**TOWN OF MOUNTAIN VILLAGE  
REGULAR DESIGN REVIEW BOARD MEETING AGENDA  
THURSDAY NOVEMBER 7, 2024, 10:00 AM  
MOUNTAIN VILLAGE TOWN HALL  
455 MOUNTAIN VILLAGE BLVD, MOUNTAIN VILLAGE, COLORADO  
TO BE HELD HYBRID THROUGH ZOOM:  
<https://us06web.zoom.us/j/89842973313>  
Meeting ID: 898 4297 3313**

**TO:** Mountain Village Design Review Board  
**FROM:** Claire Perez, Planner II  
**FOR:** Design Review Board Public Hearing; November 7, 2024  
**DATE:** October 23, 2024  
**RE:** Staff Memo – Final Architecture Review (FAR) for Lot 649R unit 10, TBD Boulders Way.

**TO:** Mountain Village Design Review Board  
**FROM:** Drew Nelson, Senior Planner  
**FOR:** Design Review Board Public Hearing; November 7, 2024  
**DATE:** October 30, 2024  
**RE:** Staff Memo – Initial Architecture and Site Review (IASR) Lot 165 Unit 17R, TBD Cortina Drive, pursuant to the CDC

*Figure 2: Height Analysis 3D Planar View*

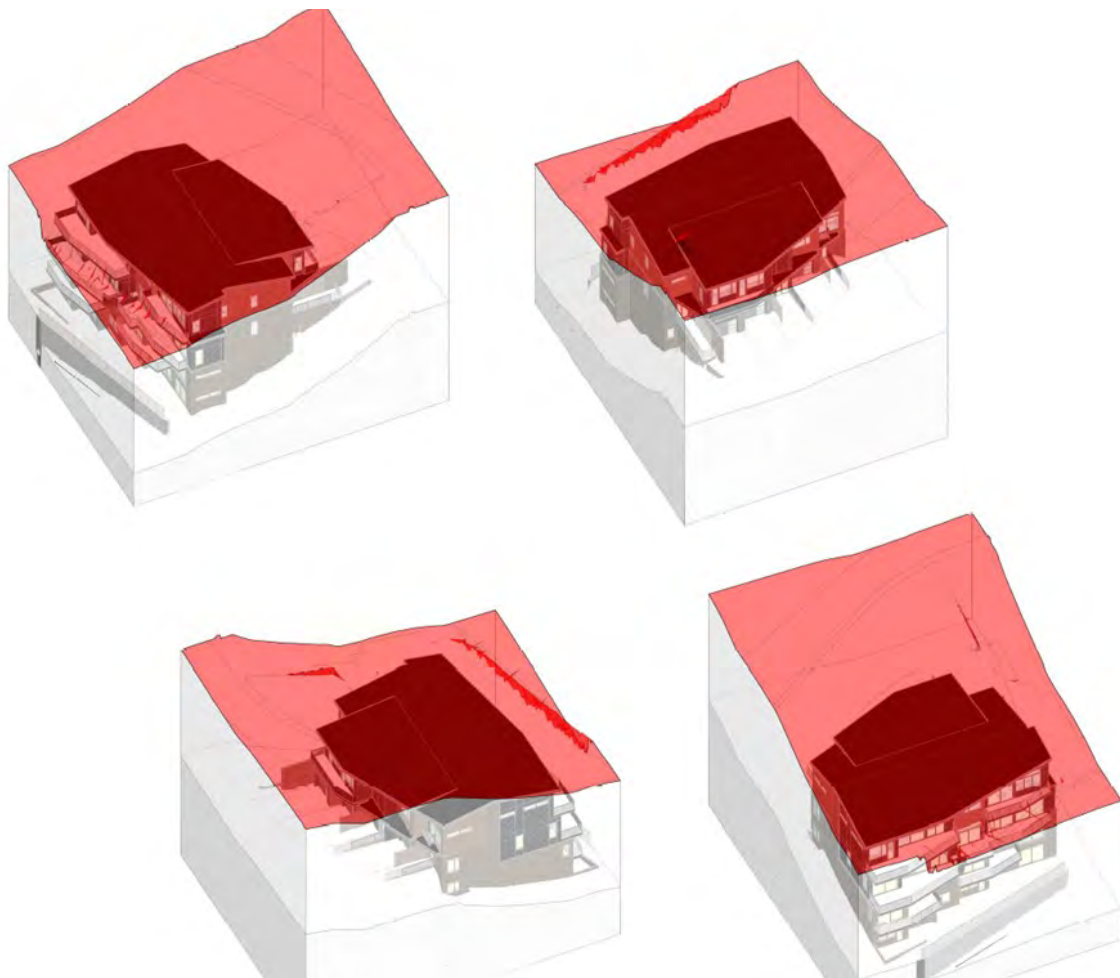
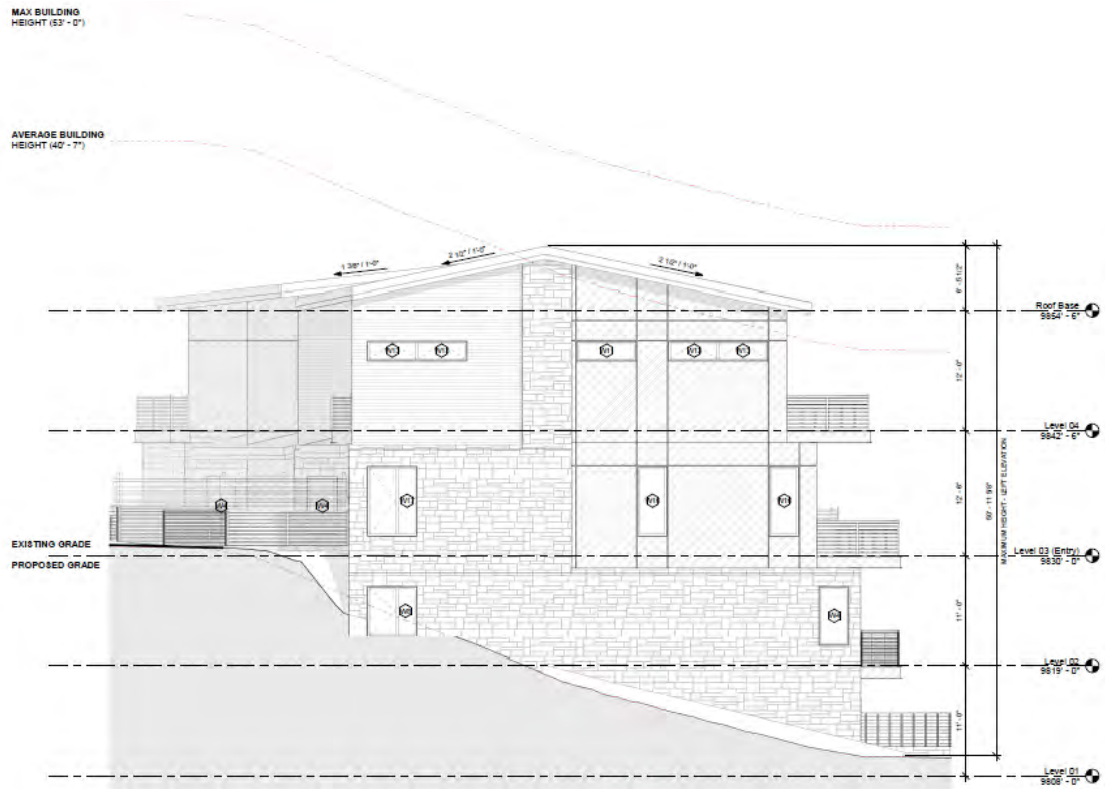
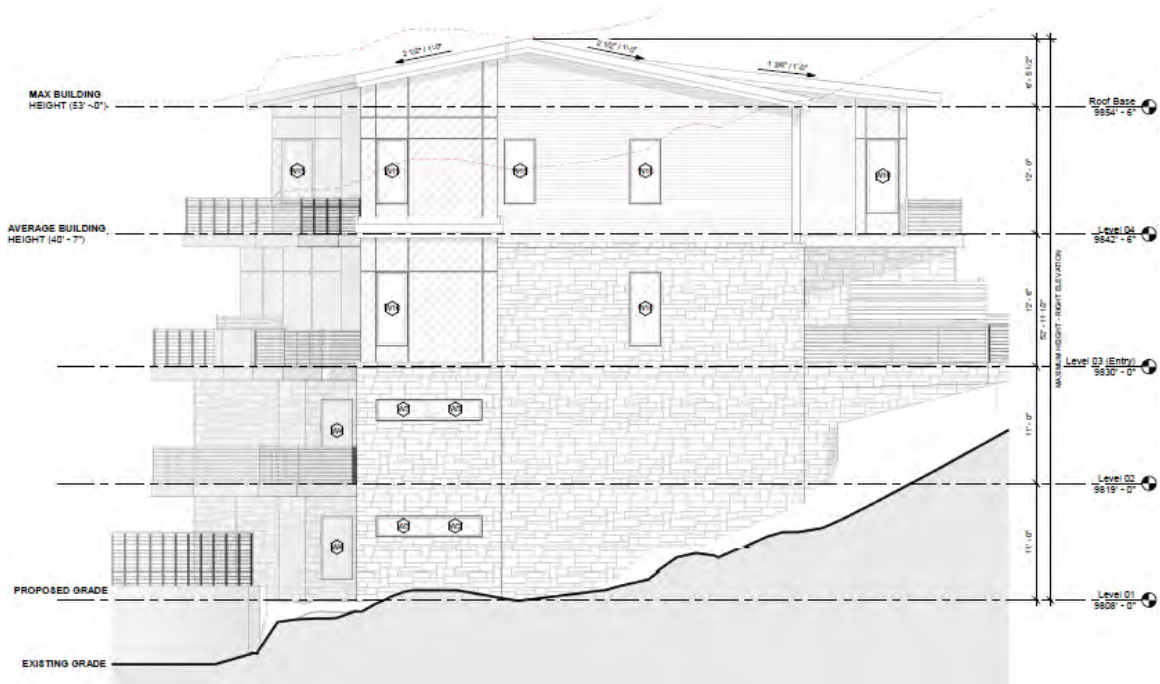
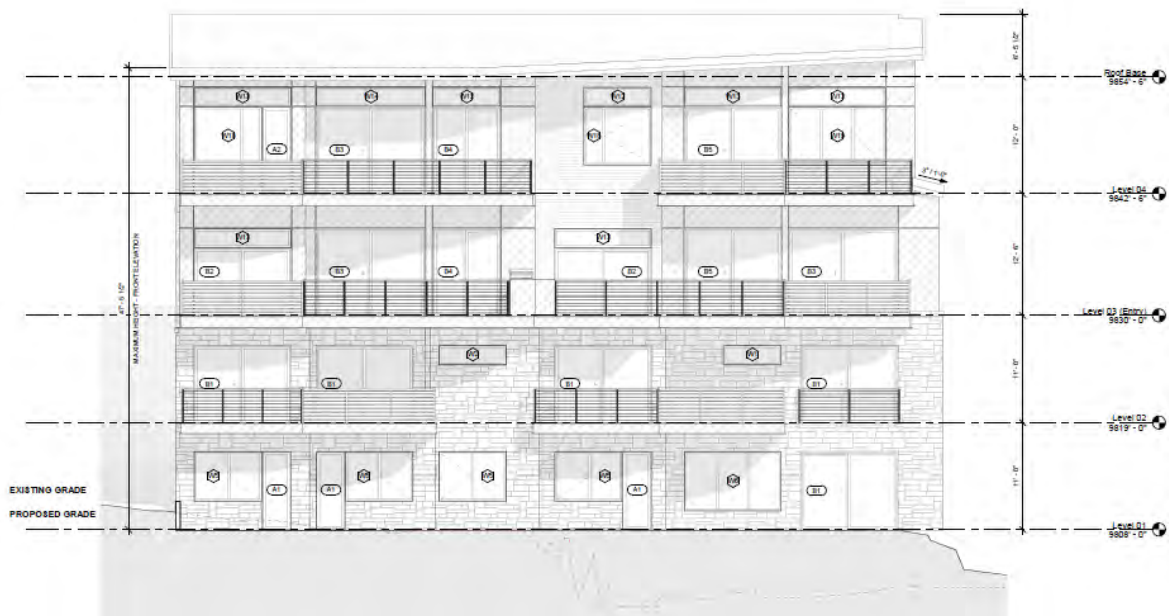
*Staff: Staff has determined that the primary roof form for this home is gabled and therefore granted a maximum height of 53' and an average maximum height of 53' for a multi-family development. According to the design set, the applicant has calculated a maximum height of 52'10" and an average height of 47'7". The applicant has provided a 3D planar view of 53' projected from the natural grade and the proposed grade in comparison to the highest point of the structure shown in Figure 2. The applicant has proposed a height measurement that purports to meet the height requirements of the CDC.*

Figure 10: Grading Plan

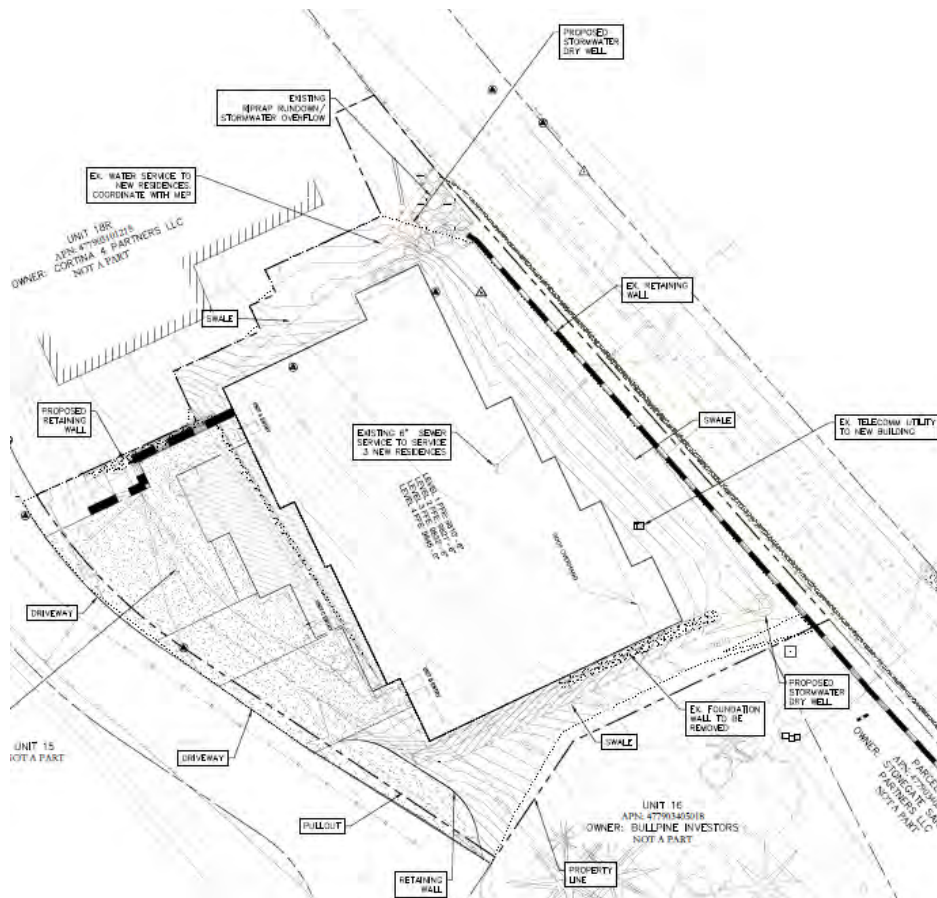
Staff: The applicant has provided a civil site plan indicating drainage swales on both the north and south sides of the structure, indicating that stormwater will drain away from the units. The applicant has also proposed stormwater dry wells on the northeast and southeast sides of the units to retain drainage. The proposal meets the standards of the CDC; however, the applicant should consider whether below-ground stormwater retention will be adequate in consideration of the size of the site.

Figure 10: Proposed Parking

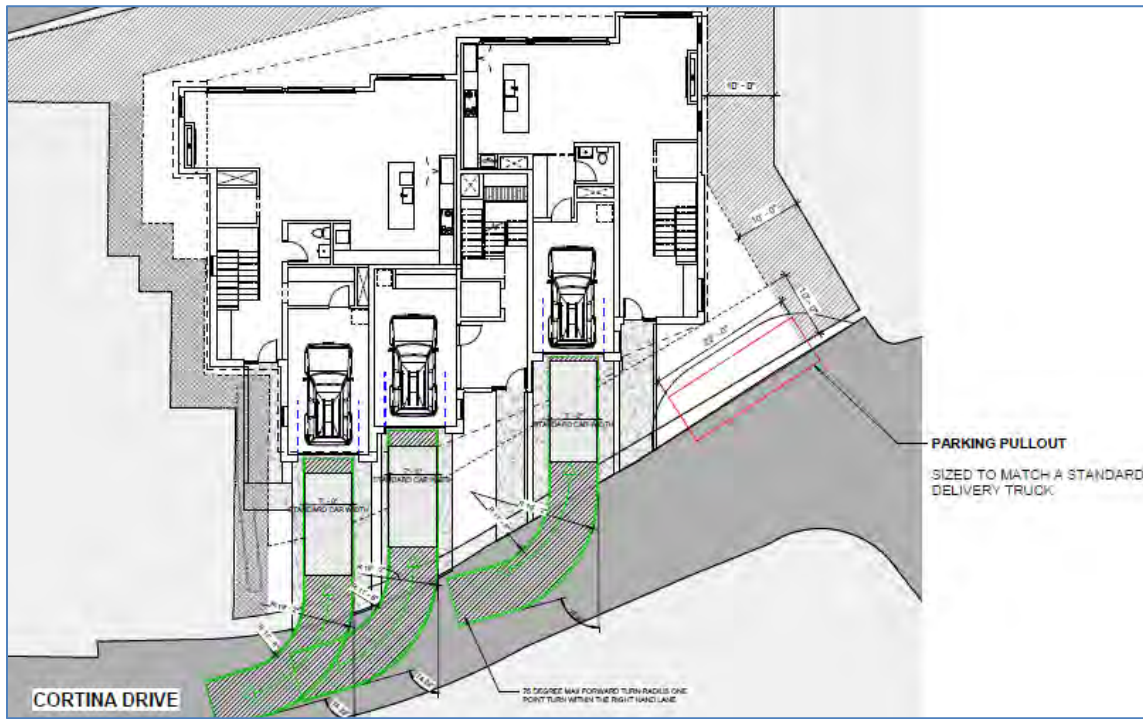
Staff: The applicant has shown three interior and three exterior parking spaces per their plan. This meets the required 1.5 spaces per unit requirement; however, the applicant's proposal of tandem parking spaces requires a Specific Approval. Since the dimensions of the interior and exterior parking spaces were not shown, prior to Final Architecture Review the applicant shall verify that all parking spaces meet the required 9' x 18' size. CDC Section 17.5.8.C.10 requires loading and unloading space of 12 feet by 55 feet for multifamily development. The applicant is proposing a "parking pullout" for a delivery truck with dimensions of 10 feet by 22 feet, which does not meet the standards of the CDC and would require a Design Variation. The DRB should discuss whether a waiver of the delivery truck dimensions is suitable for management of the site, in conjunction with the location of the vehicle turnaround at the end of Cortina Drive.

**A5.01**

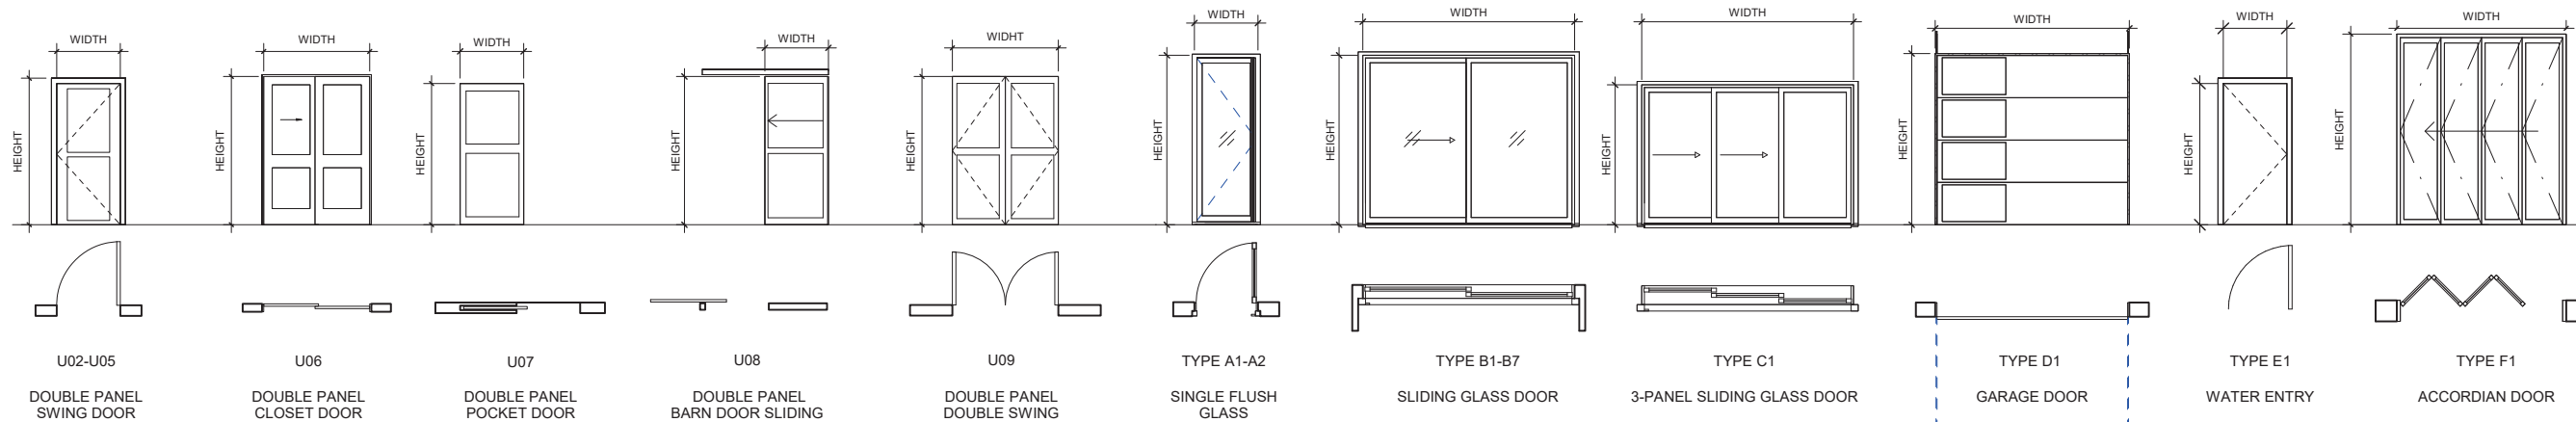
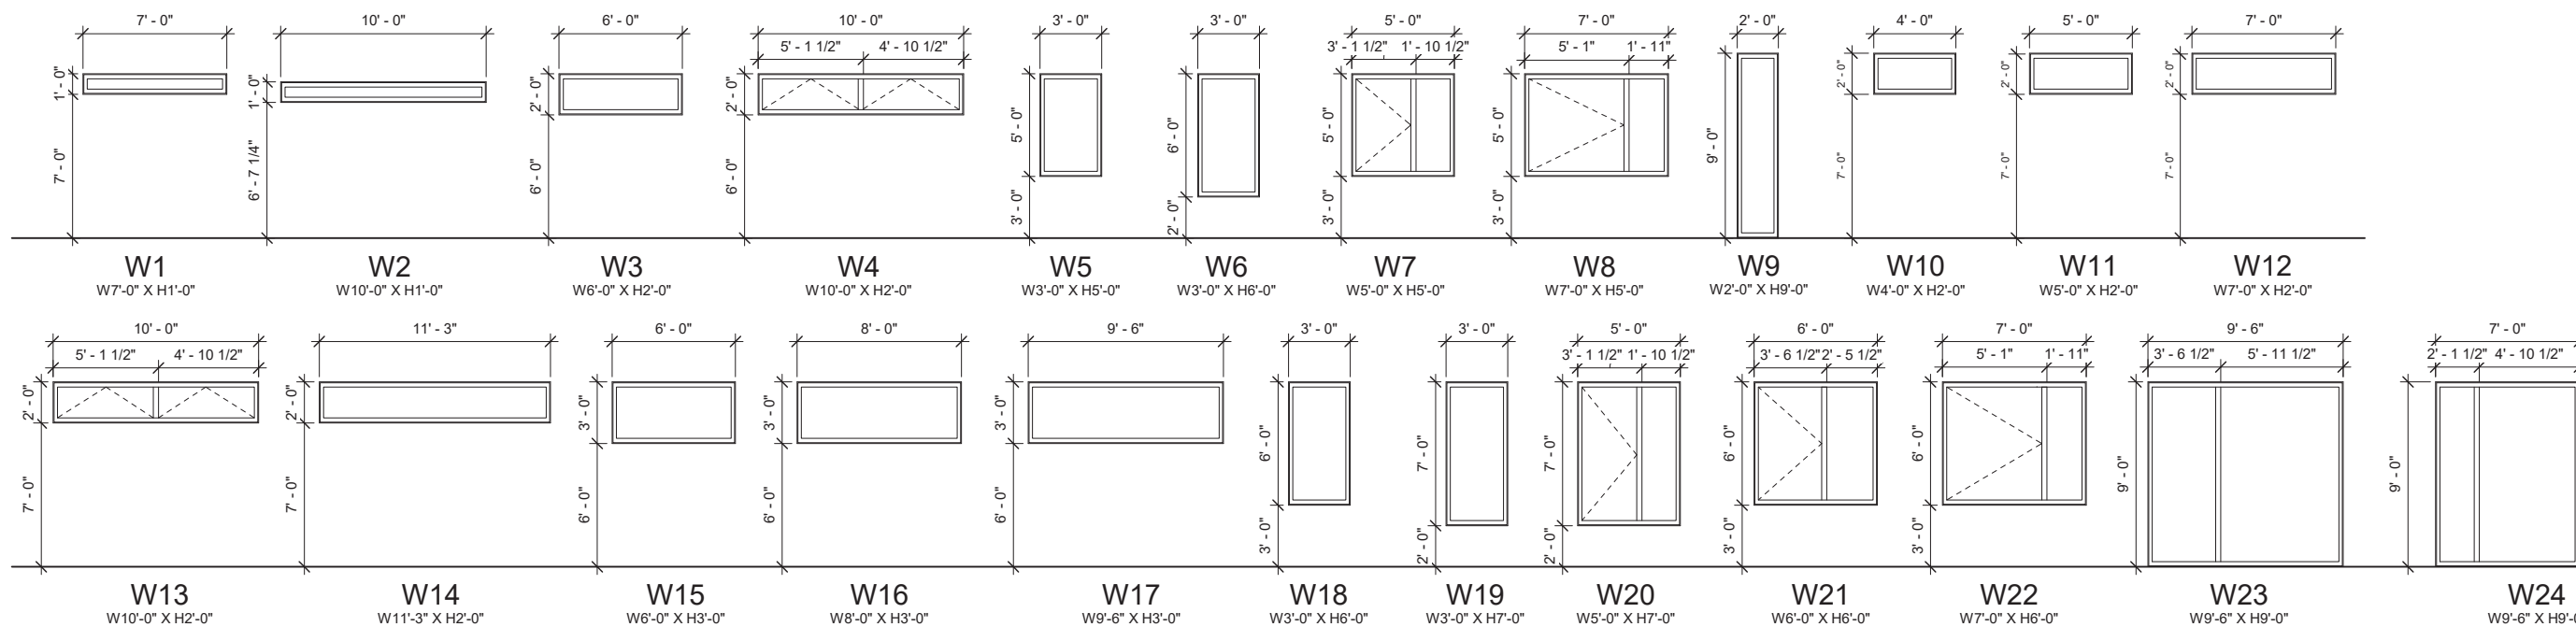
*Sheet A5.01 of the design set shows the window and door schedules, as well as schedule for the three garage doors. Prior to Final Architecture Review, the applicant shall provide window design specifications to ensure that window recess requirements of the CDC are met.*
